17-067FDP DUBLIN METRO DENTAL

Proposal

A one-story, 13,000 square-foot building for a dental office and future tenant space.

8) Signs

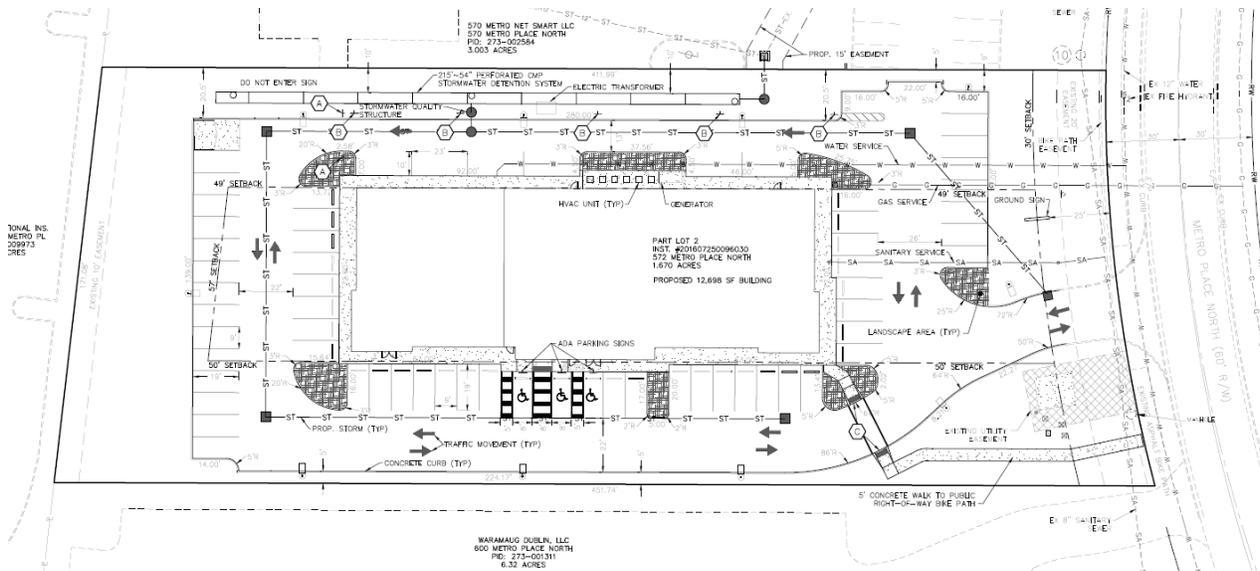
A ground sign is proposed at the site entrance to the east of the existing driveway. The applicant has proposed a brick base with flanking stone columns. The sign face would be stucco with raised lettering and ground lighting. The two tenant panels will be designed to meet Code requirements. The size is proposed at 50 square feet and will meet the required setback of eight feet from the right-of-way. The sign is proposed at a height of nine feet. As proposed, the sign meets Code requirements.
